SUSQUEHANNA SES UNIT 2 CYCLE 5

TECHNICAL SPECIFICATION CHANGES

SEPTEMBER 1990

PENNSYLVANIA POWER & LIGHT COMPANY

FLOW DEPENDENT MCPR OPERATING LIMIT
FIGURE 3.2.3-1

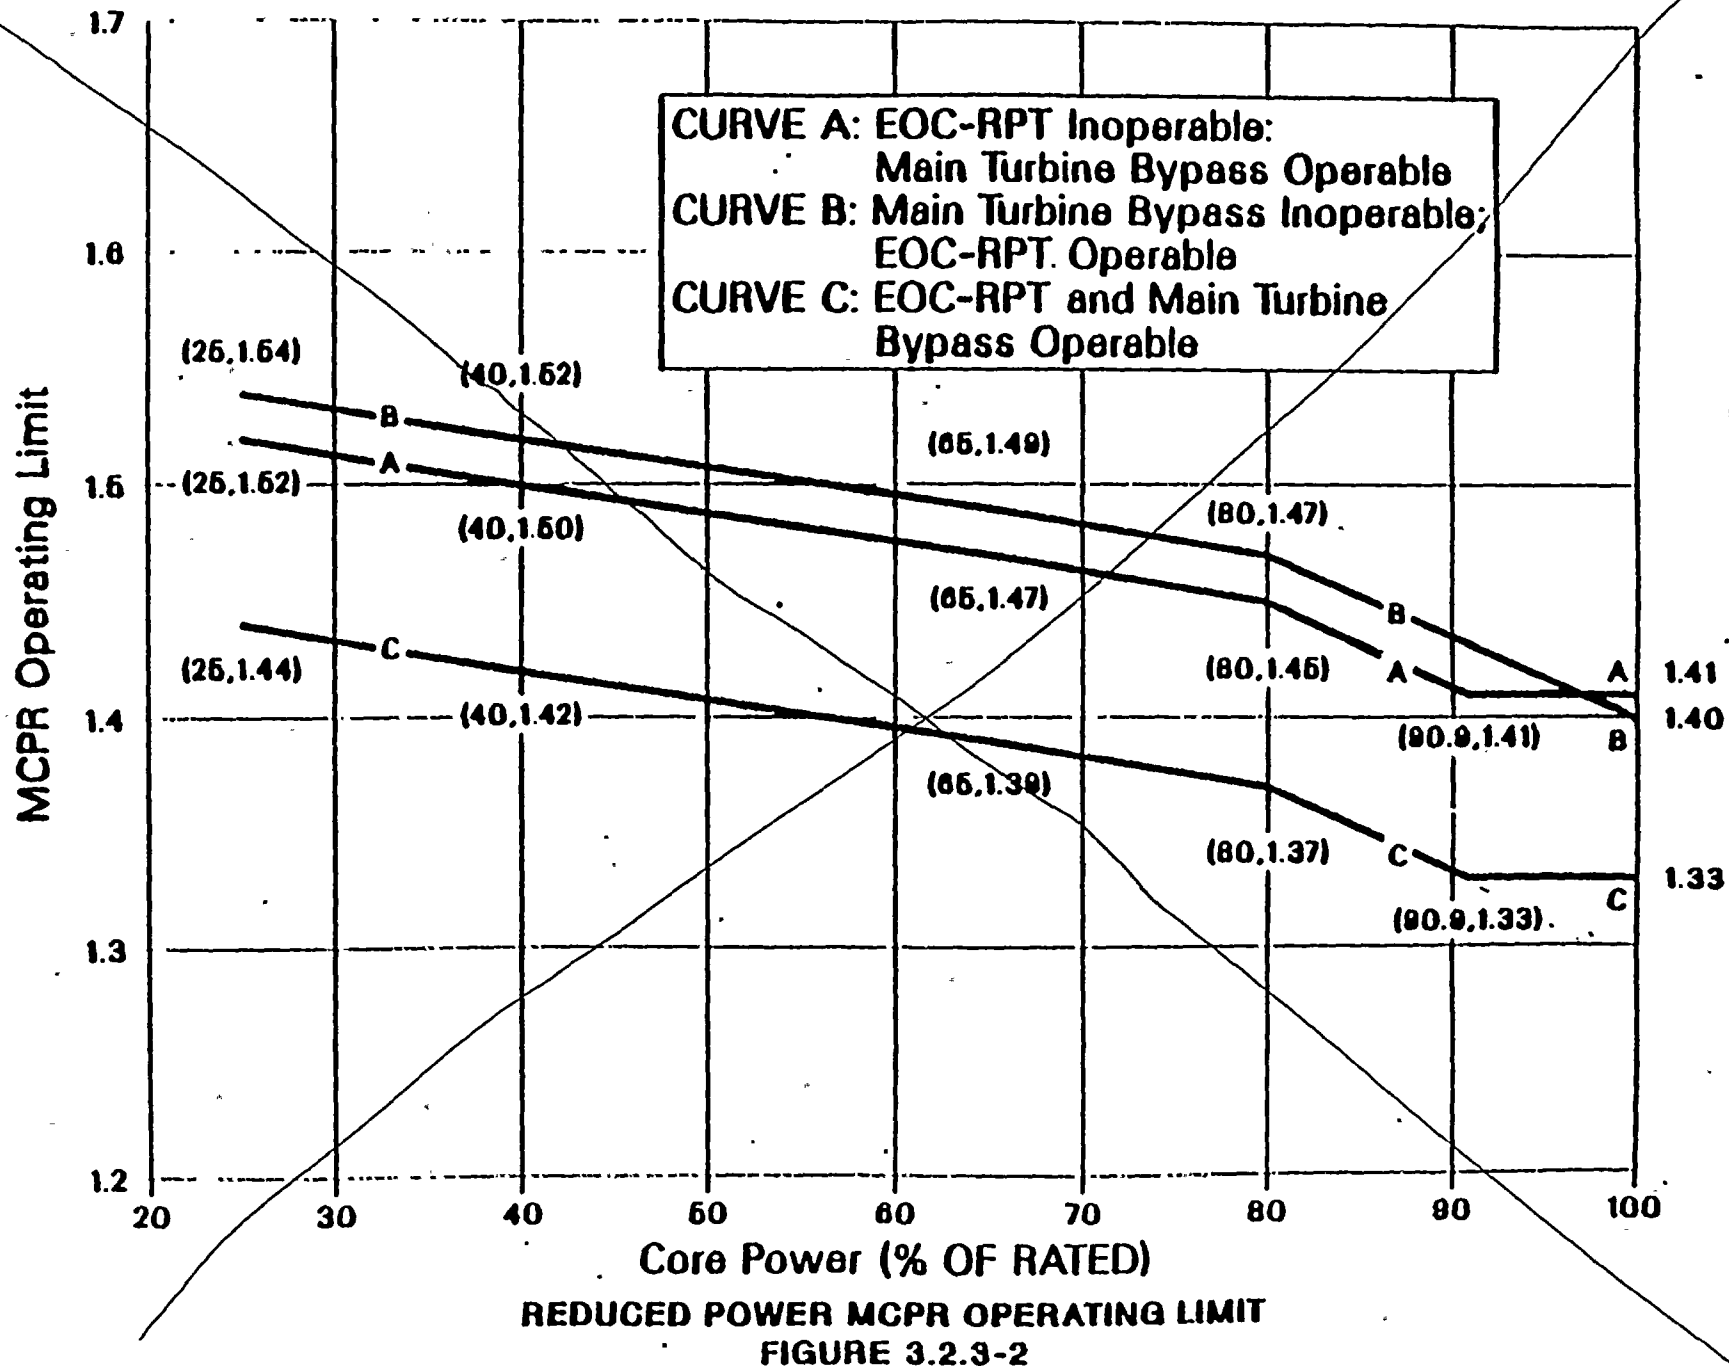
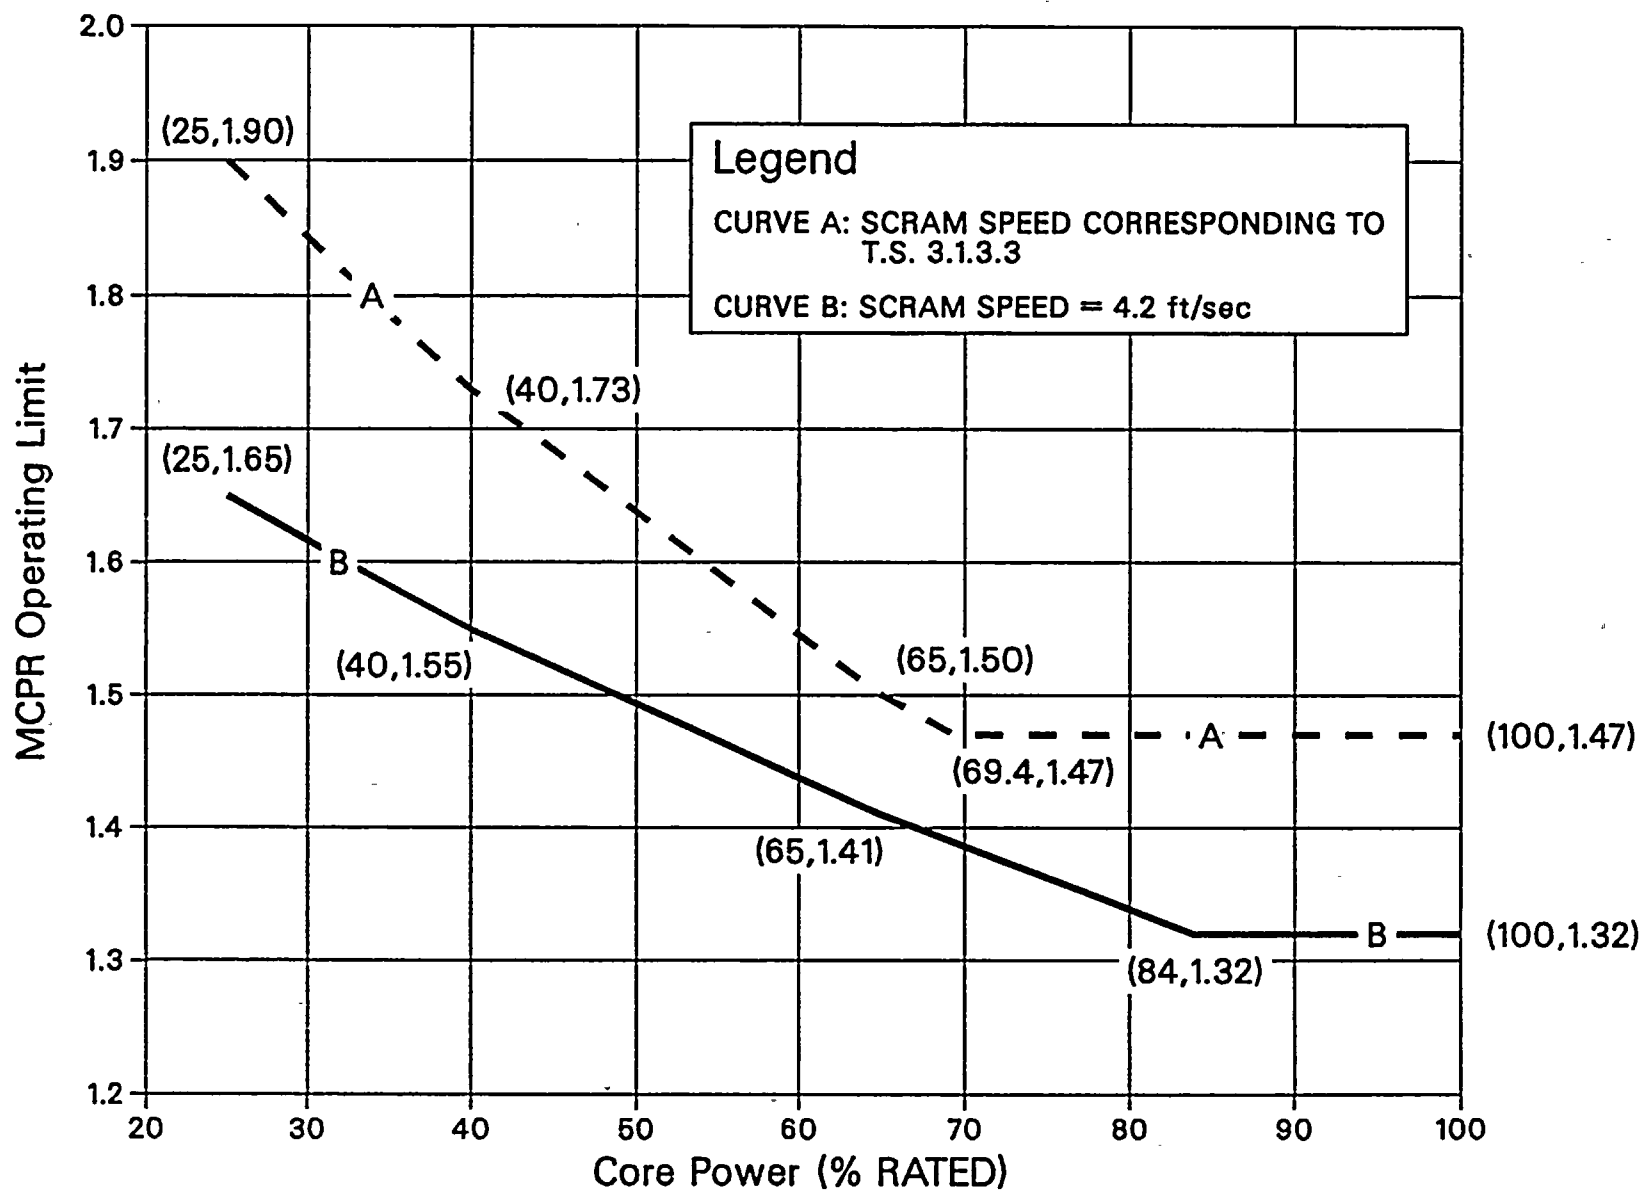
REPLACE WITH THE FOLLOWING PAGE

Insert 15 → Figure 3.2.3-1 defines core flow dependent MCPR operating limits which assure that ~~the Safety Limit MCPR will not be violated~~ during a flow increase transient resulting from a motor-generator speed control failure. The flow dependent MCPR is only calculated for the manual flow control mode. Therefore, automatic flow control operation is not permitted. Figure 3.2.3-2 defines the power dependent MCPR operating limit which assures that the Safety limit MCPR will not be violated in the event of a Feedwater Controller Failure, Rod Withdrawal Error, or Load Reject Without Main Turbine Bypass operable initiated from a reduced power condition.

- a) The Flow-Dependent MCPR value determined from Figure 3.2.3-1, and
- b) The Power-Dependent MCPR value determined from the following equation:

REDUCED POWER MCPR OPERATING LIMIT
EOC-RPT AND MAIN TURBINE BYPASS OPERABLE
FIGURE 3.2.3-2

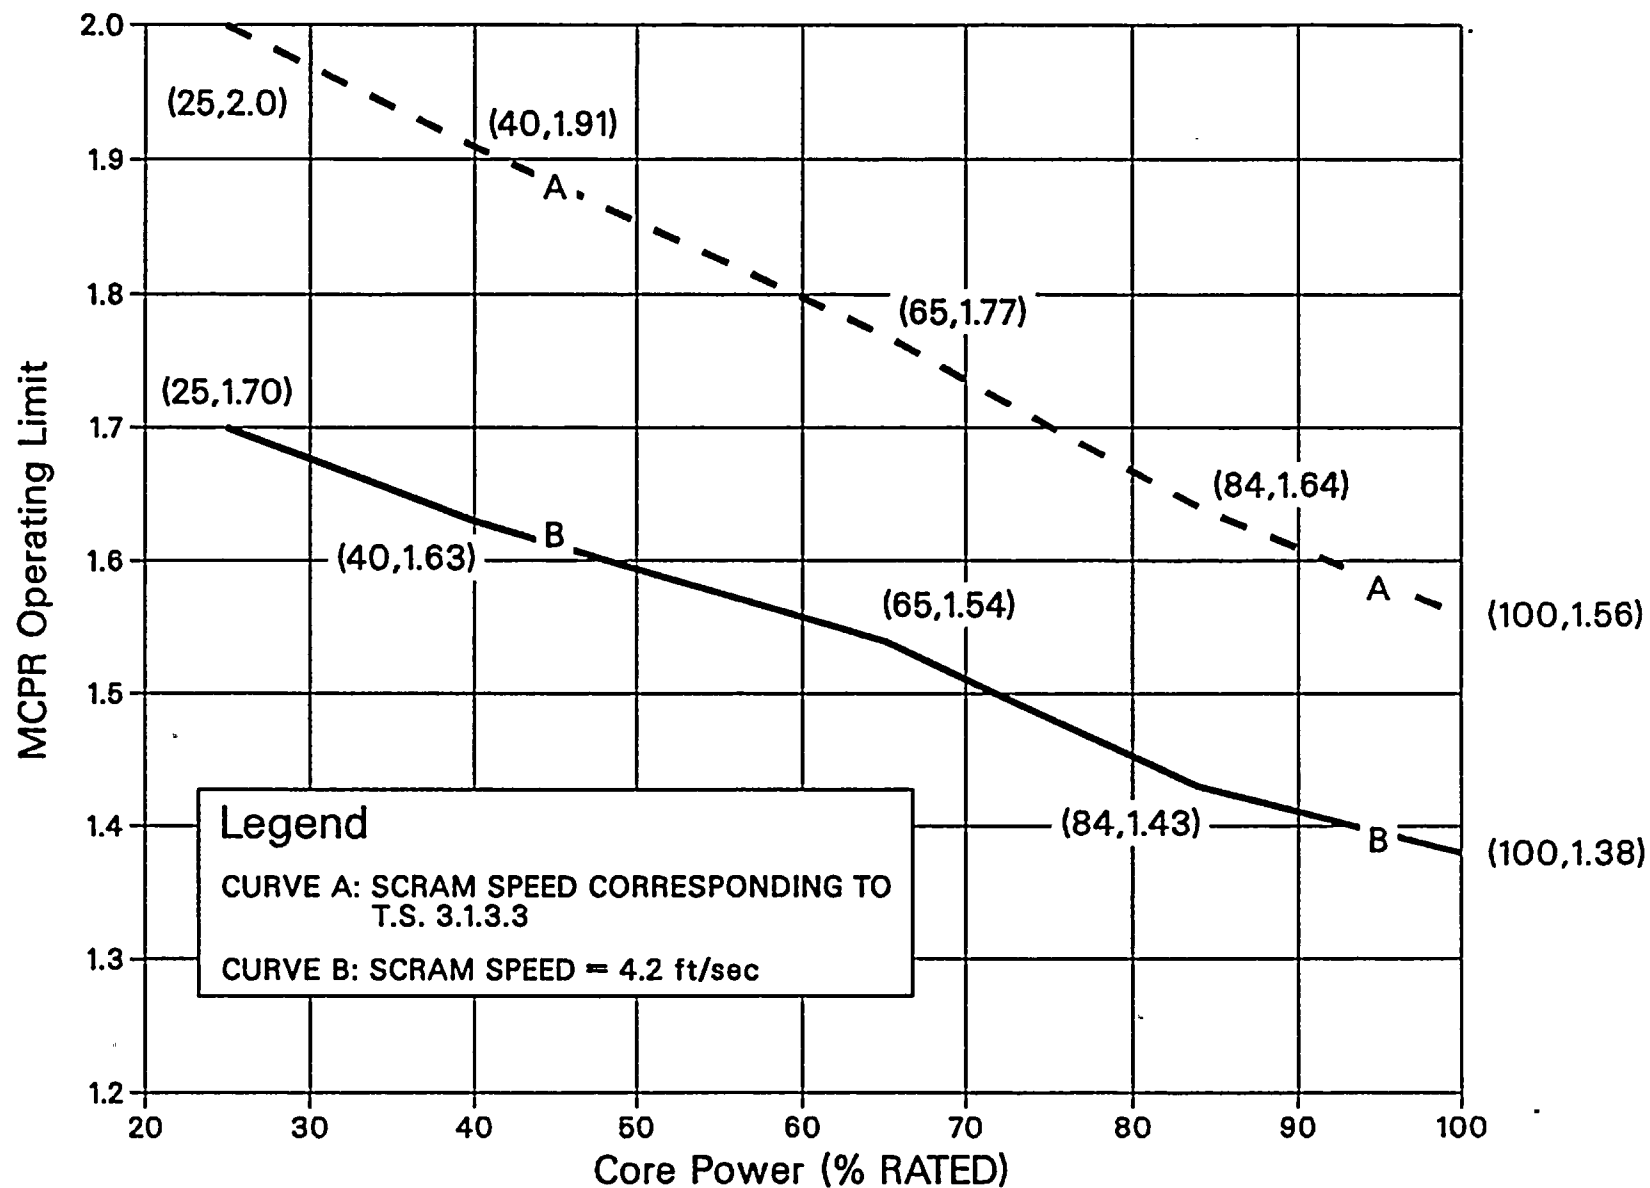
Figure 3.2.3-2: EOC-RPT and Main Turbine Bypass Operable

REDUCED POWER MCPR OPERATING LIMIT
MAIN TURBINE BYPASS INOPERABLE
FIGURE 3.2.3-3

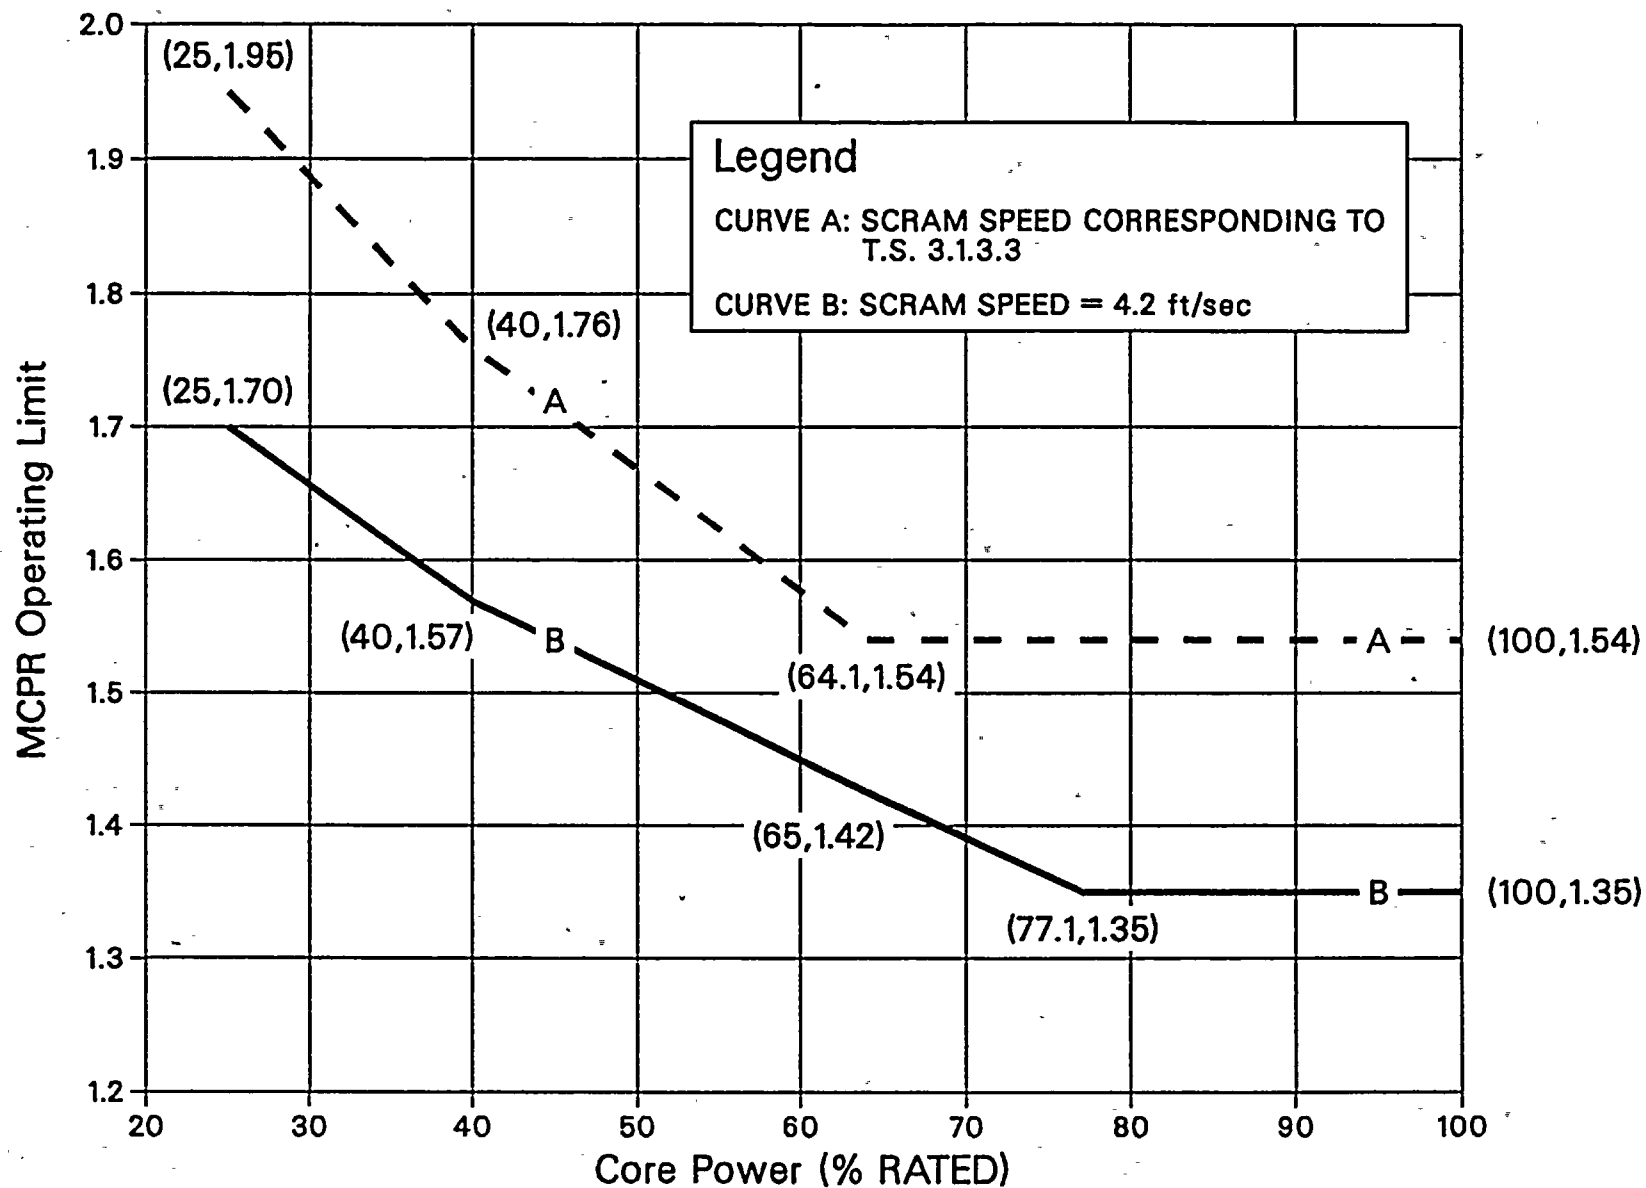
Figure 3.2.3-3: Main Turbine Bypass Inoperable

Figure 3.4.1.1.1-1
THERMAL POWER RESTRICTIONS

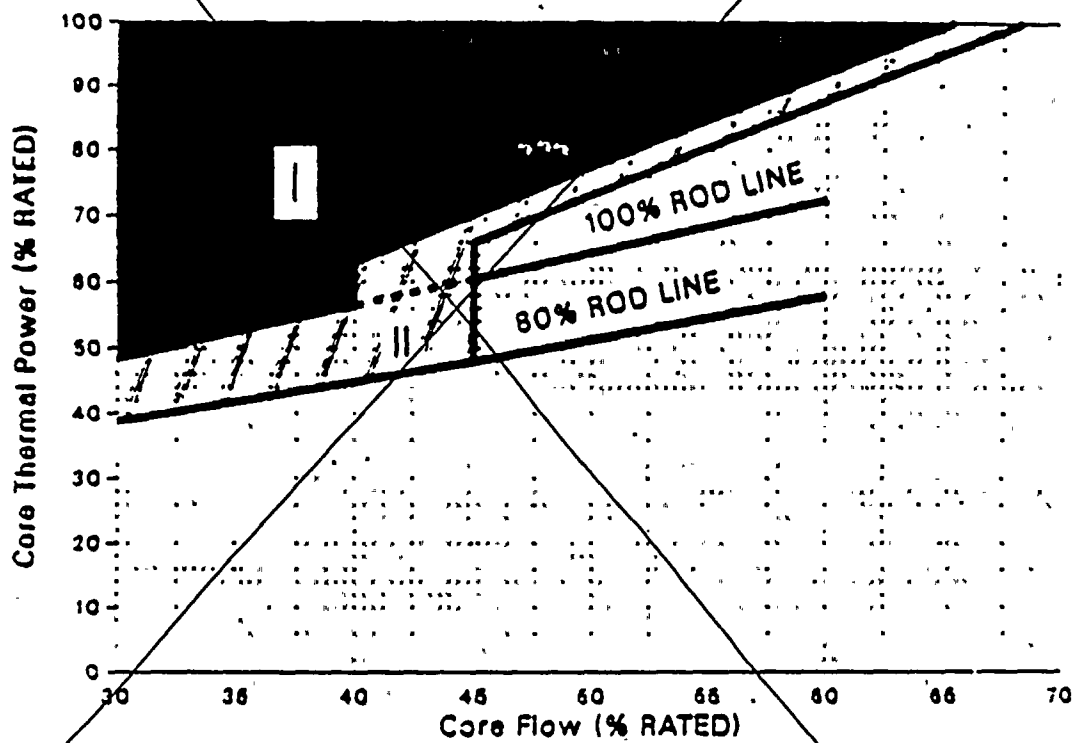
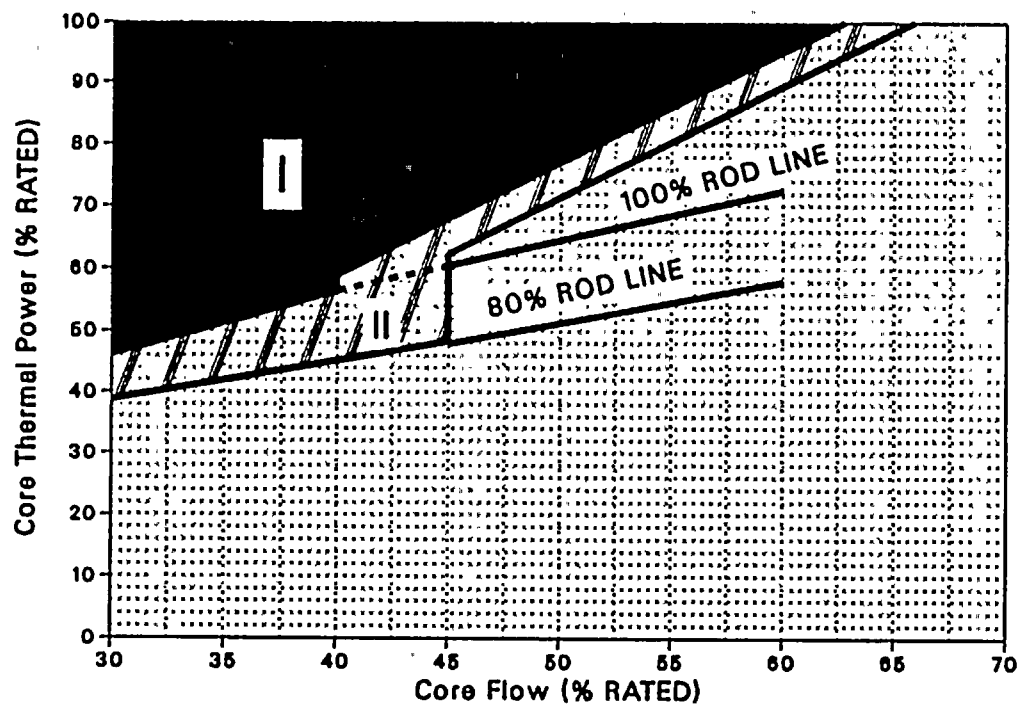
REPLACE WITH THE FOLLOWING PAGE

The changes to this specification (i.e., Figure 3/4.1.1.1-1) reflect cycle-specific stability analyses.

Figure 3/4.1.1.1-1 is also referenced by Specification 3/4.4.1.1.2, which governs Single Loop Operation (SLO). The evaluation above applies under SLO conditions as well.

3.4.1.1.2 One reactor coolant recirculation loop shall be in operation with the pump speed $< 80\%$ of the rated pump speed and the reactor at a THERMAL POWER/core flow condition outside of Regions I and II of Figure 3.4.1.1.1-1, and
